**PRODUCT BULLETIN # 16570**

**TITLE:** Shipping Tube change for SOIC Wide Body (SOIC WB) devices at ON Semiconductor Carmona, Philippines

**PRODUCT BULLETIN # 16571**  
Generic Copy

**TITLE:** Shipping Tube change for SOIC Narrow Body (SOIC NB) devices and QSOP at ON Semiconductor Carmona, Philippines

Figure1. Details of change

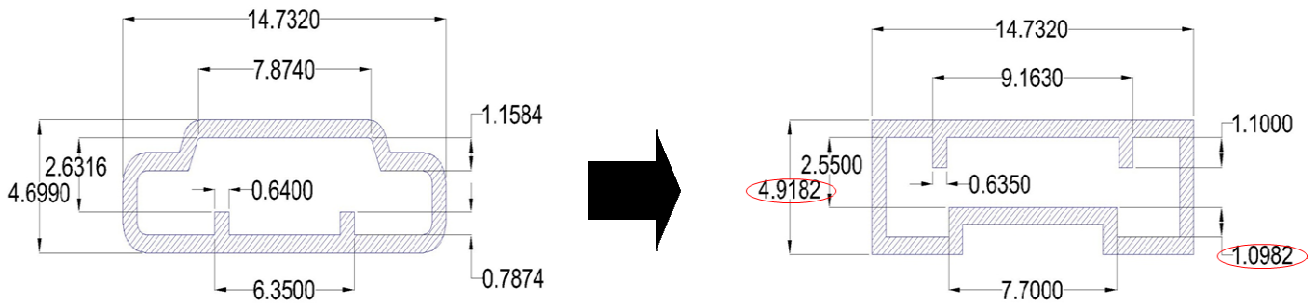
ON Semiconductor Carmona is changing the shipping tube used for SOIC WB packages. This includes dimension change within the JEDEC specification and supplier change. The change is considered as a quality and packaging robustness improvement.

- Length = 20.000 ± 0.050 inch
- End plug on both ends
- Supplier: ITW Ampang, Laguna, Philippines

- Length = 20.6751 ± 0.050 inch
- Crimp at one end
- Supplier: YOSIKO, Bulacan, Philippines
